Product Advisory

Form 12945 - GPA - 004

New Model H-10917 Slide Gate Valve

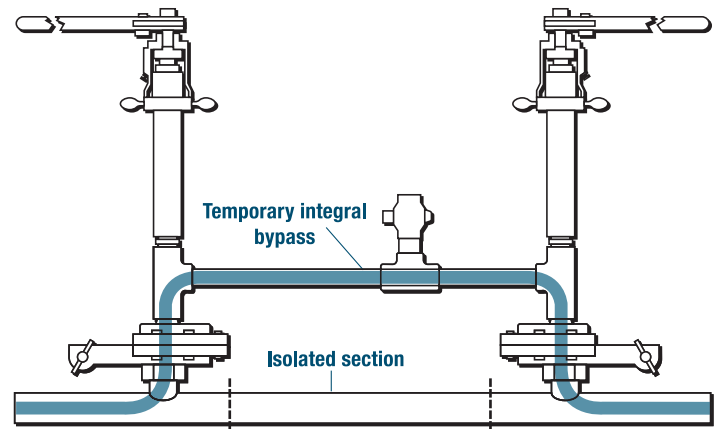
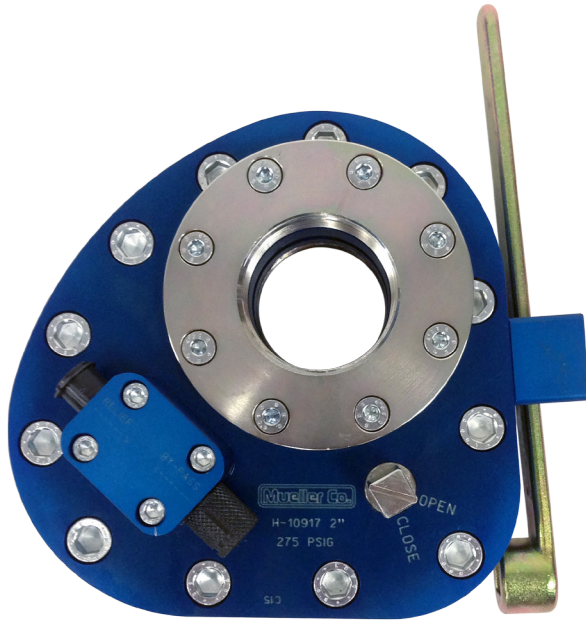
Mueller Company is introducing a new model H-10917 Slide Gate Valve. Commonly used in many small diameter line stopping applications, the 2015 model incorporates many new upgrades providing ease of use and field maintenance.

- High strength aluminum body reduces weight by up to 40% depending on size.
- Steel replaceable threads provide easy field replacement if damaged.
- O-ring seals deliver leak-free operation and simple maintenance.
- Low Profile
- 275 psig

Effective (9/8/2015) the "Yellow" Pre-2015 style Slide Gate Valve will no longer be available for purchase as a complete unit. Orders for H-10917 Slide Gate Valves will be filled with the new improved "Blue" model after this date. When submitting purchase orders, please use part numbers included in this advisory. Mueller will continue to supply replacement gaskets, slide gates, and hardware for old style valves. Top and bottom ductile bodies will no longer be available for purchase after 9/8/2015. Please contact local Mueller Regional Account Manager with any questions.
